# West Oakland Link Initial Study/ Mitigated Negative Declaration Addendum

**NOVEMBER 2024**

### 1.3 Proposed Revised Project

Figure 1-7b

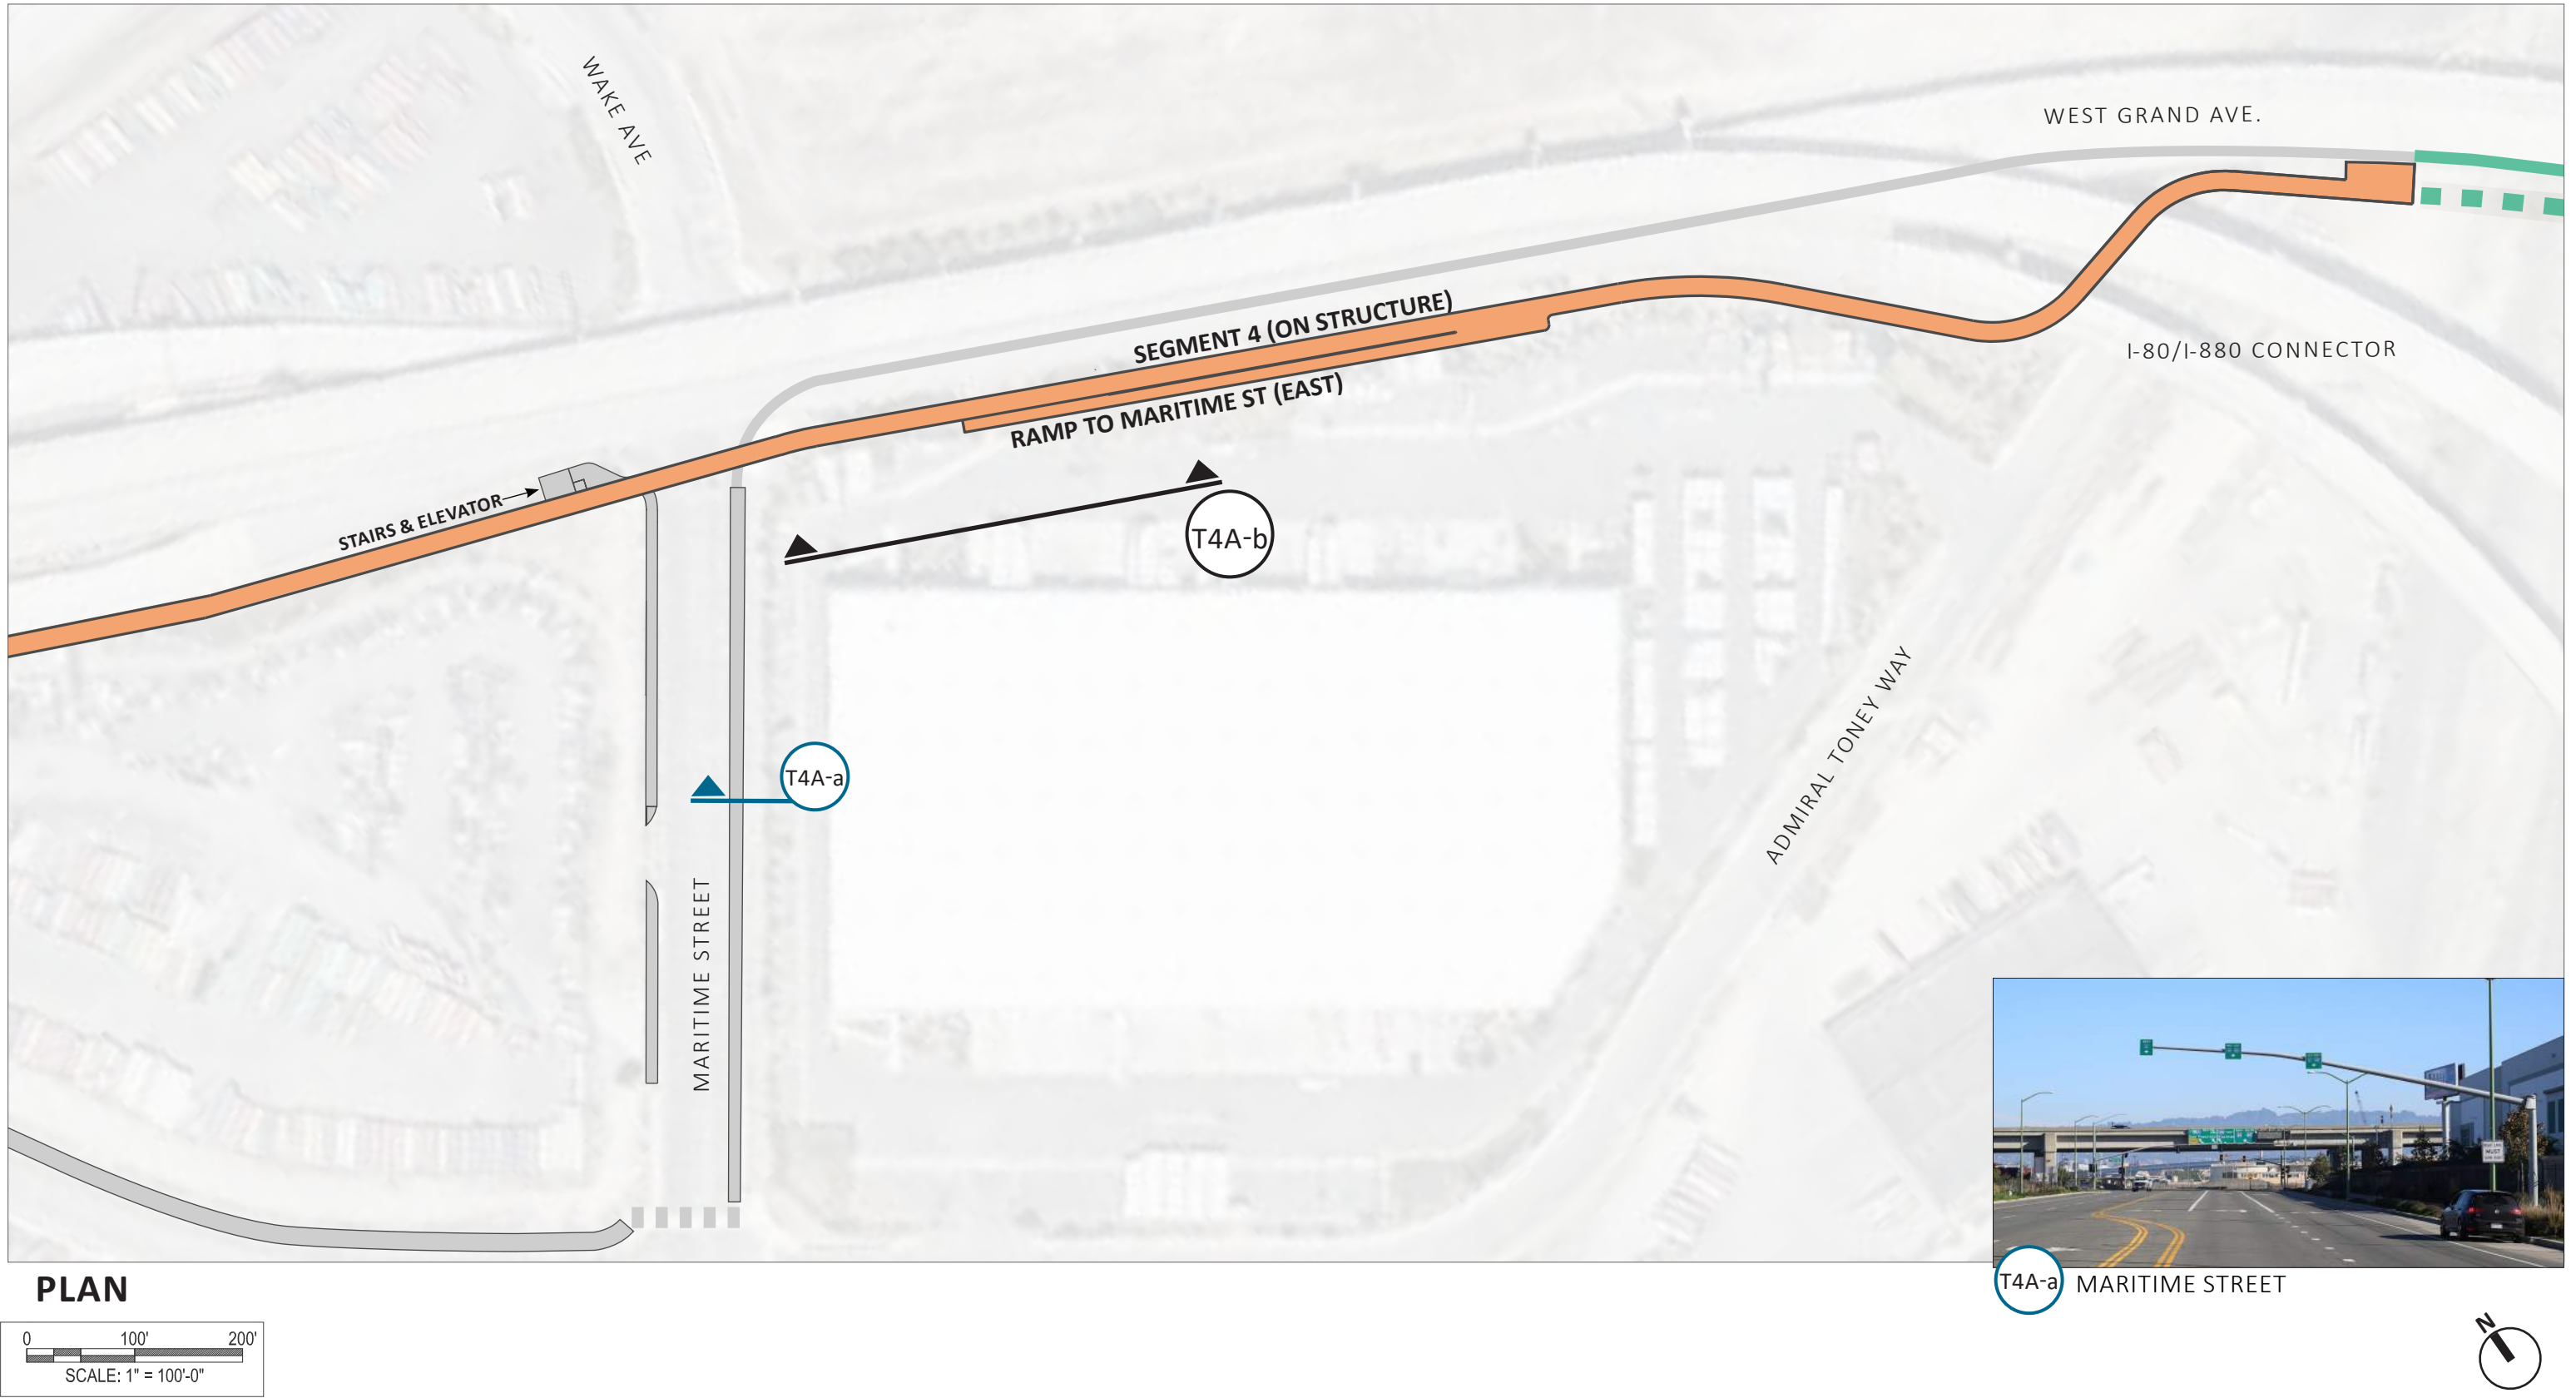
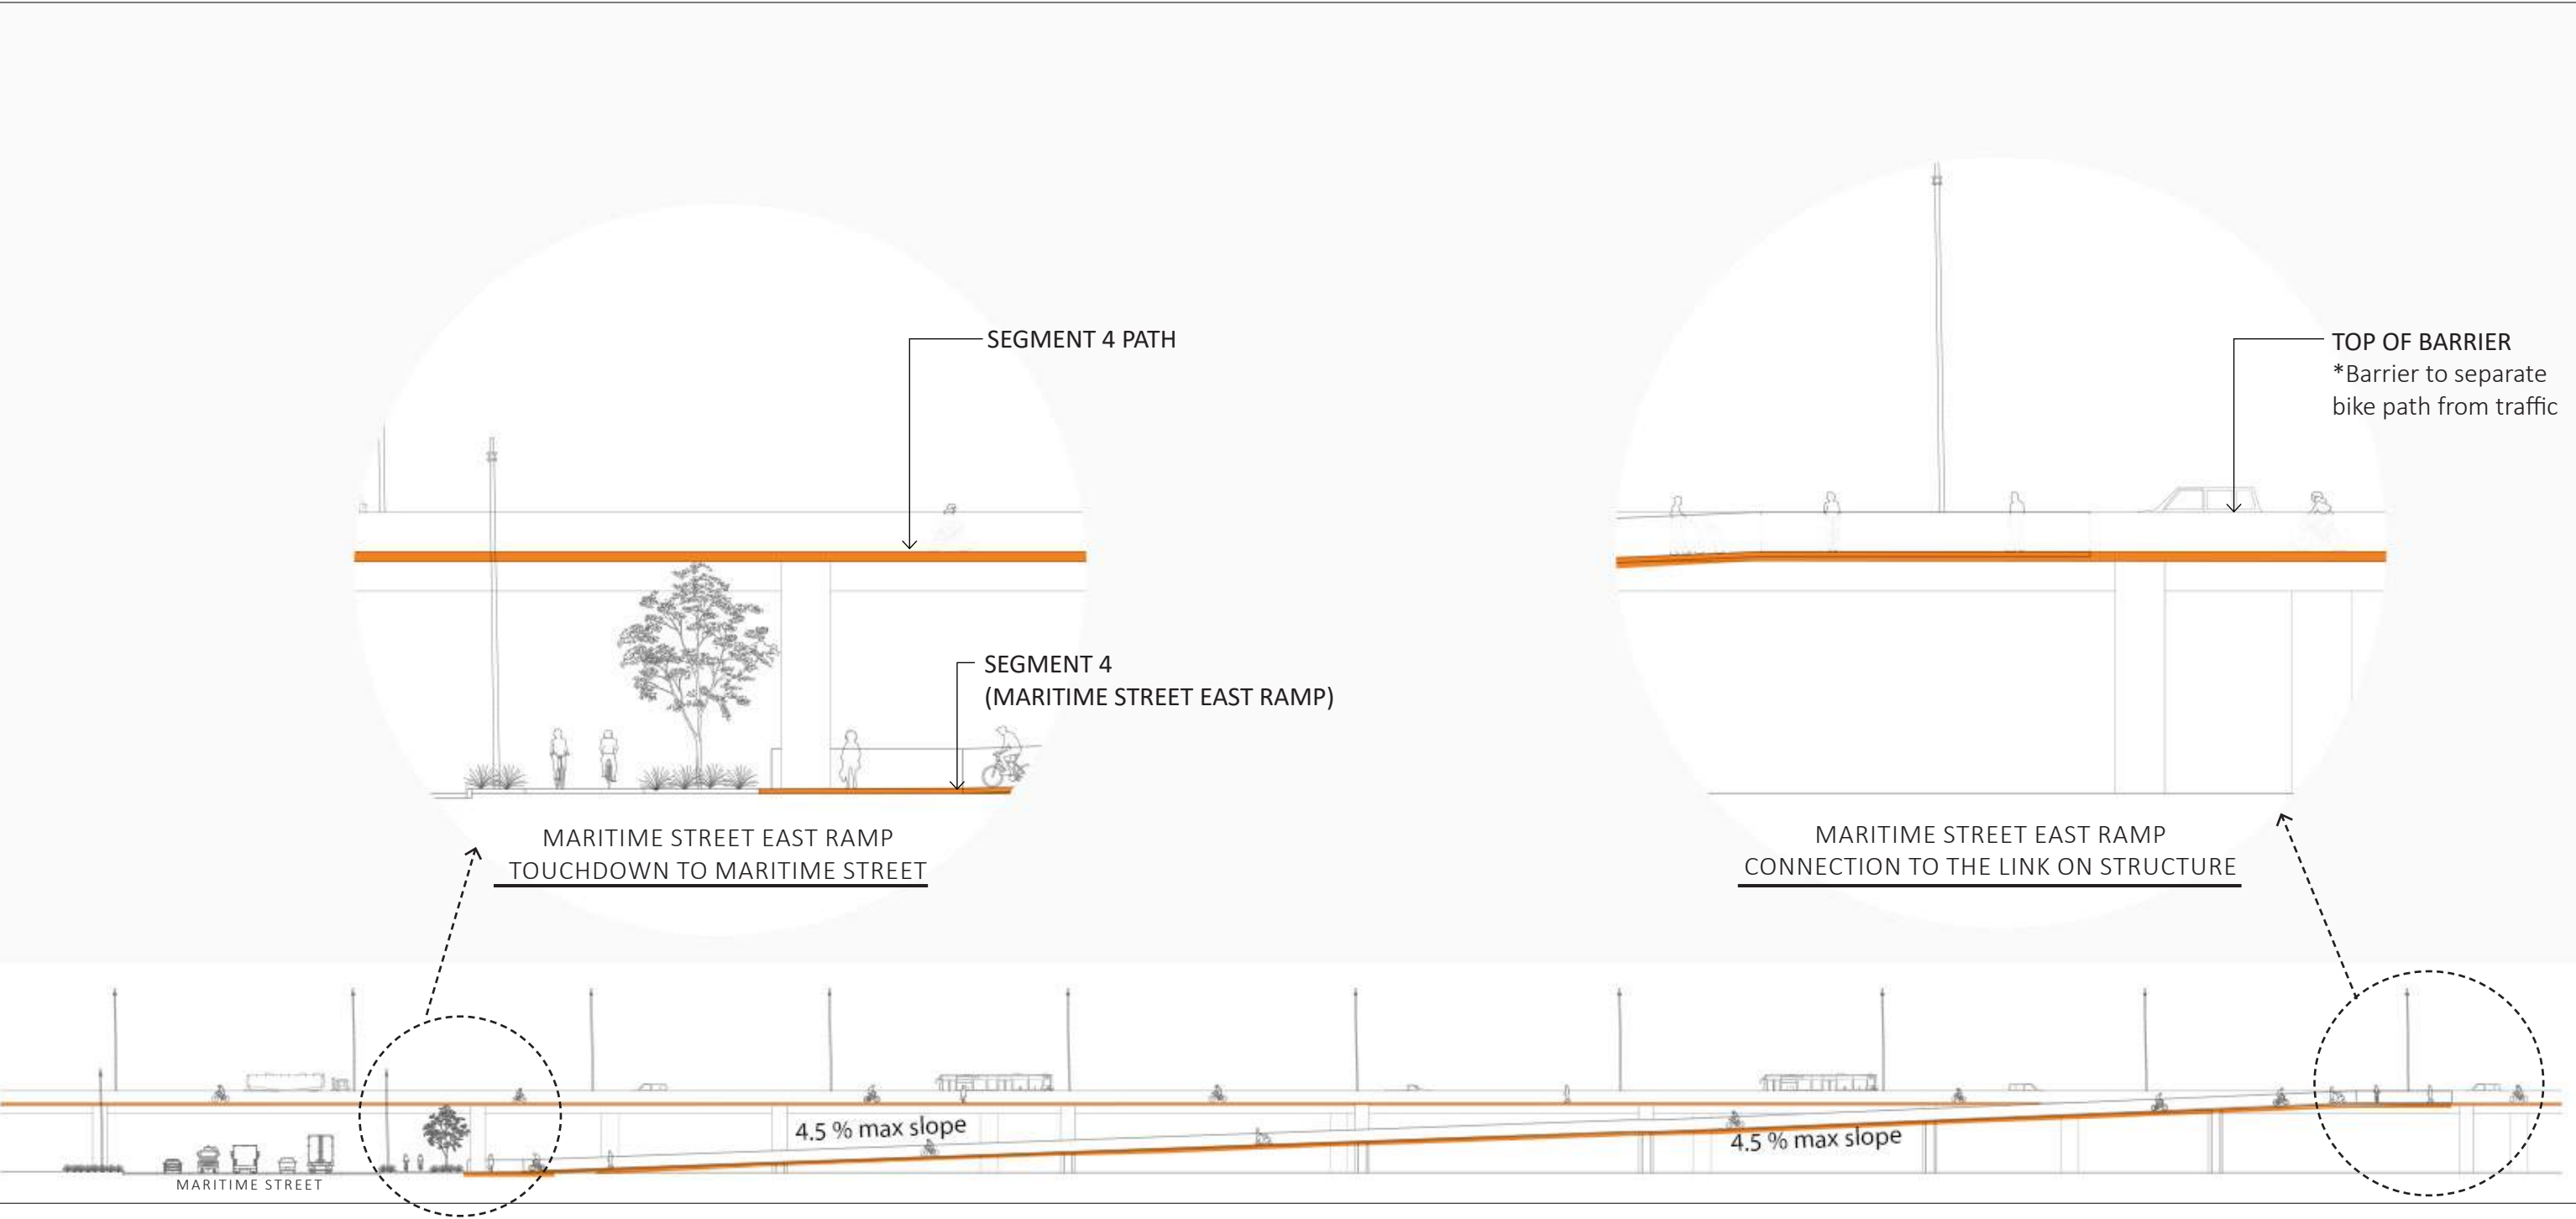
Segment 4 of the Proposed Revised Project is shown in Figures 1-7a and 1-7b and Figures 1-8a, 1-8b, and 1-8c. As shown in Figures 1-7a and 1-7b, a ramp would connect to the Class I path on the east side of Maritime Street and be parallel to the West Grand Avenue structure on the south side. The ramp on the west side of Maritime Street, proposed in the Approved Project to connect to a building in the planned OMSS development, would be removed from the project. At this vicinity, stairs and a future elevator may be constructed to allow access to the west side of Maritime Street and the planned OMSS development. The separate elevated path of the Proposed Revised Project also differs from the Approved Project by reversing the loop alignment in the vicinity of the rail crossings. Segment 4 would include two seating areas that would be located on the structure, providing a bench and shade. This would be set back from the path striping but within the overall pathway area.
